Current Zoning: NS (Neighborhood Services) and N2-B (Neighborhood 2-B)  
Proposed Zoning: N2-B(CD) (Neighborhood 2-B, Conditional)

Approximately 8.43 acres located along the north and south side of Mintworth Avenue, west of Margaret Wallace Road, and east of Wyalong Drive

The petition proposes to allow for the development of up to 64 multi-family attached dwelling units on a site that is currently undeveloped.

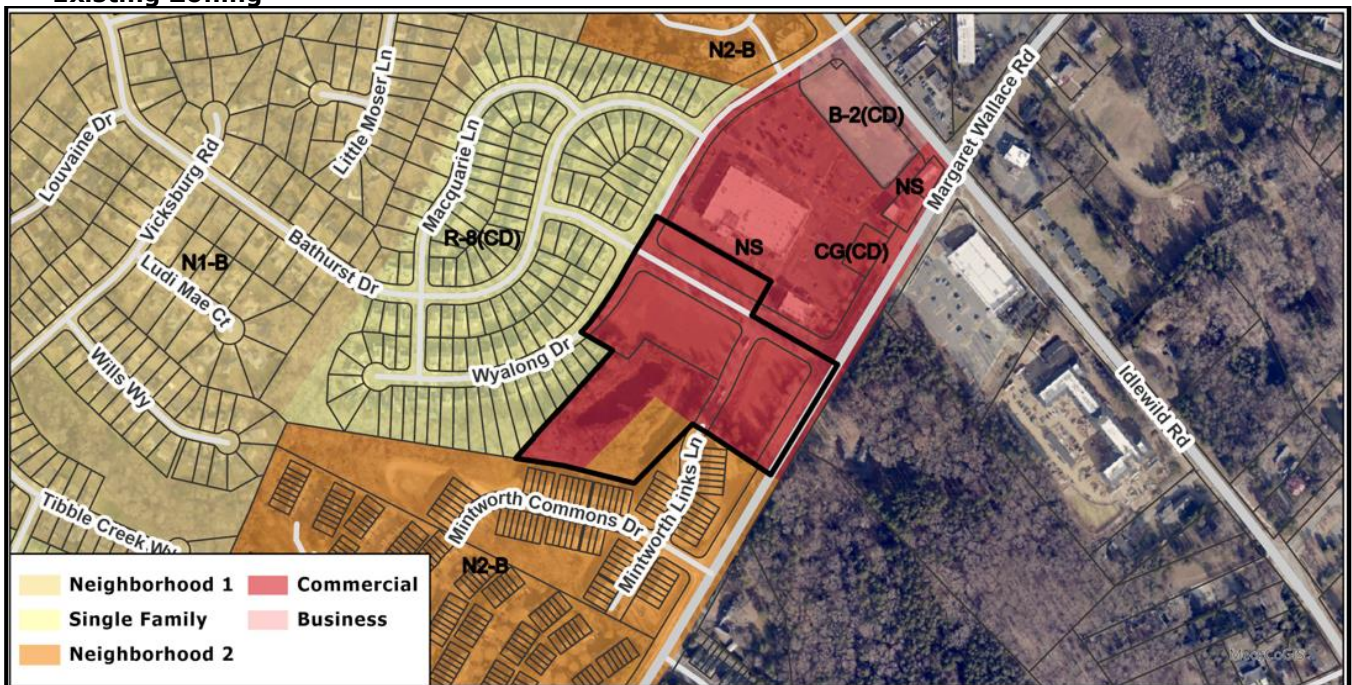
1. Please identify where the 15% green area will be provided.
2. Please show the open spaces provided and include their square-footages in the data table and commit to enhanced design elements.

3. Change proposed uses from single family attached to multi-dwelling development in the development data table.
4. Garage setbacks are already determined in CLDSM and UDO. Any more restrictive standard opted on the rezoning would need to be specified from back of pavement or back of sidewalk along alley, not centerline, otherwise remove the reference if using the base ordinance standard.

5. Remove sub-lot side yard in development data table and on site plan.
6. Remove front setback of 20-feet or specify "20-feet from future back of curb".

7. Show and label 5-foot side setback.
8. Show and label 20-foot rear yard.
9. Consider and include additional design standards related to prominent porches and stoops, roof form and articulation, enhanced screening around waste and mechanical equipment, etc.

10. Provide notes on how open space areas will be amenitized and directly accessed by future residents.

11. Please show how many solid waste containers will be provided, their size, and their conformity with Article 21.3 & 21.4 of the UDO.
12. Remove section 9 of the conditional notes regarding signs if no conditional notes are to be provided.

13. The future back of curb location on revised plans shows existing curbline. Future back of curb needs to be dimensioned and shown at 27-feet as curb line is to be relocated on Margaret Wallace Road.

14. The conditional notes must be updated to include an 8-foot planting strip and 8-foot sidewalk along Margaret Wallace Road.
15. The future back of curb location needs to be dimensioned on revised plans. While the curbline is not being relocated, this dimension of 17.5-feet must be included from roadway centerline. Since existing roadway is larger than Charlotte Streets Map designation, dimension of future back of curb may terminate in the middle of roadway on Mintworth Road.

16. The future back of curb location needs to be dimensioned on revised plans for Mintworth Links Lane.
17. The future back of curb location needs to be dimensioned on revised plans. While the curbline is not being relocated, this dimension of 17.5-feet must be included from roadway centerline. This will require your right-of-way to be shifted accordingly on Wyalong Drive.

18. 30-feet of right-of-way is acceptable, but SUE will be required to extend an additional 5.5-feet on Mintworth Links Lane.
19. An SUE of 2-feet must be added from the back of sidewalk on Wyalong Drive.

20. Please dimension ROW for Wyalong on the north side of the Mintworth Avenue / Wyalong intersection.

21. Revise site plan and conditional note(s) to commit to construct bicycle facilities by locating the curb and gutter 27-feet from the center line on Margaret Wallace. This note was intended for Margaret Wallace and not Wyalong Drive. Please correct conditional note and revise site plan. This was listed in conditional notes but also should be shown on site plans.
  22. The 50-foot driveway stem requirement cannot be waived and must be utilized for approval. Remove parking spaces adjacent to driveway to achieve appropriate stem.
  23. Fix conditional notes to specify 8-foot sidewalks and 8-foot planting strip along site's frontage.
  24. Please remove where feasible, SUE will need to be included to at least 2-feet behind sidewalk for all frontages.
-
